IREDELL COUNTY HEALTH DEPARTMENT

IMPROVEMENT PERMIT / AUTHORIZATION TO CONSTRUCT / OPERATION PERMIT / EXISTING SYSTEM INSPECTION

PERMIT# 100692 PIN# 4741884548 DATE 2-28-05

SUBDIVISION Martha's Vineyard BLOCK / SECTION II LOT 48 LOT AREA .86 Acre SITE CLASS. PS DESIGN FLOW 450 gpd L.T.A.R. .3

INITIAL SITE SKETCH Scale 1" = 50'

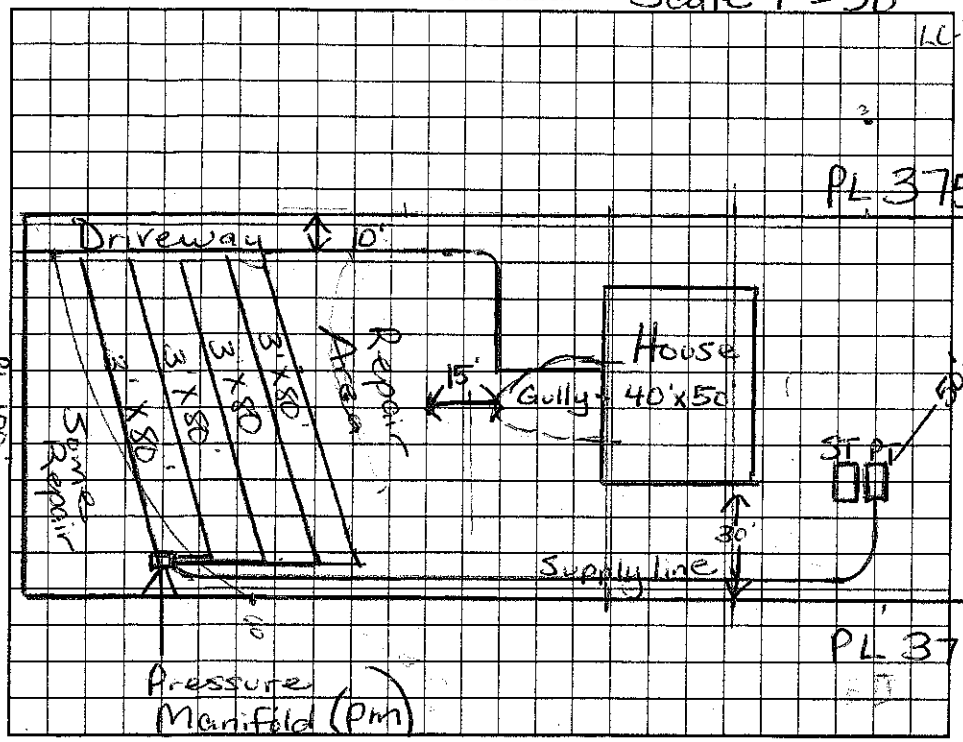
Comments/Conditions: Keep Septic System at least 10' From PL, 50' From well & 15' from Cut > 2ft. (Supply line 5ft from PL)

Comments/Conditions: Note: Very tight to get 25% Reduction for Drainfield; must hug PL with driveway. Install Drainlines on Contour.

KEEP DRIVEWAY OFF AS BUILT SKETCH OF SYSTEM & REPAIR

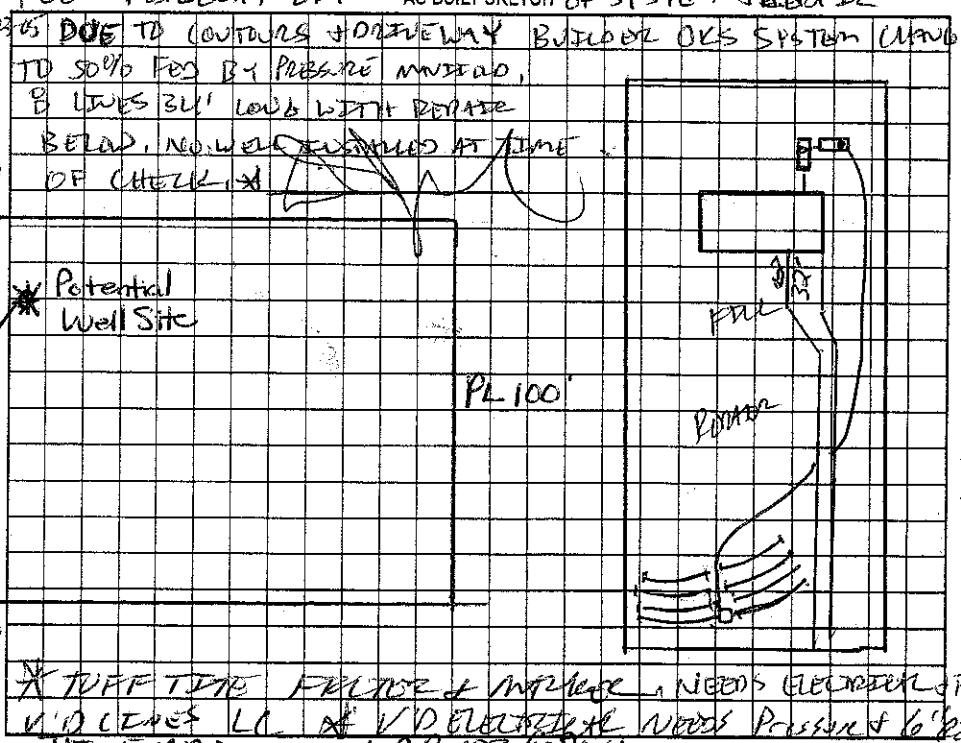
DUE TO CONTOURS & DRIVEWAY BUILDER OKS SYSTEM CHANGES TO 50% FED BY PRESSURE MANIFOLD, & LINES 3@ 80' LONG WITH REPAIR BELOW, NO WELL EXISTED AT TIME OF CHECK

STAFF TIME FAILURE & INSPECTION, NEEDS ELECTRICAL & PUMP; V/D CLOSE LC & V/D ELECTRICAL NEEDS PRESSURE & 6" RISER

JAIME V/D PRESSURE V/D RISER 6-20-06
